Work Order ID 88135

Item Name: Replacement Skidtube

| DRAWING NO. D2590 | TITLE 204 SKIDTUBE ASSEMBLY | REV. E | DART AEROSPACE LTD ENGINEERING ORDER | | D.E.O. NO. D2590-E-1 | SHEET NO. SHEET 1 OF 1 | SCALE NTS |

SECTION F-F D5-5
SCALE 5X

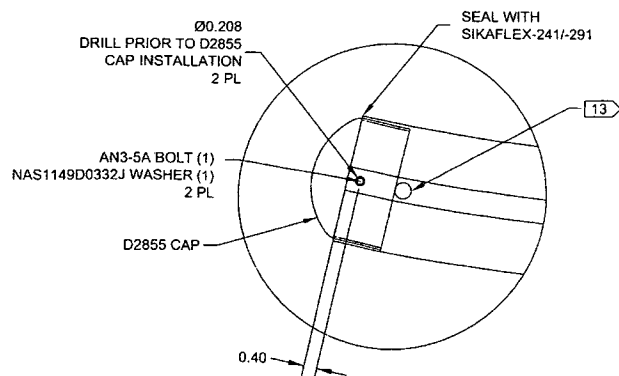
- AFTER DRILLING AND BENDING ASSEMBLY
PERFORM THE FOLLOWING FOR Ø0.508 HOLES ONLY:
1. CHAMFER HOLE 0.050 X 45°
 2. INSERT D2579 SPACER (22 PLACES)
 3. WELD INTO PLACE AND GRIND FLUSH
 4. C'BORE D2579 SPACER TO Ø0.437 X 1.00 DEEP

SECTION B-B & F-F IS AMENDED AS FOLLOWS:

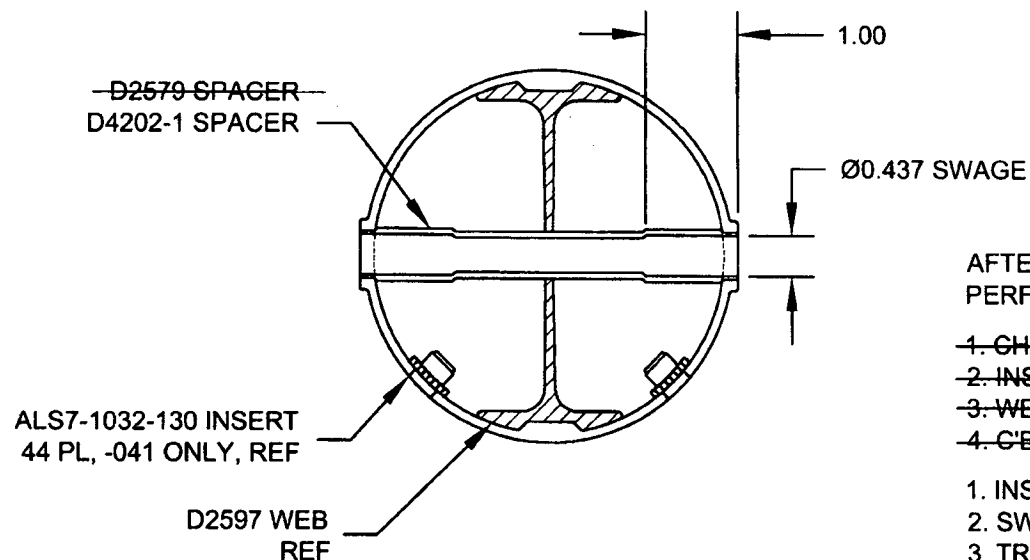
CHANGE ALL WELDED CROSSBOLT SPACERS TO SWAGED SPACERS

| 17 | 22 | D4202-1 | SPACER |

SECTION B-B & F-F
NOT TO SCALE
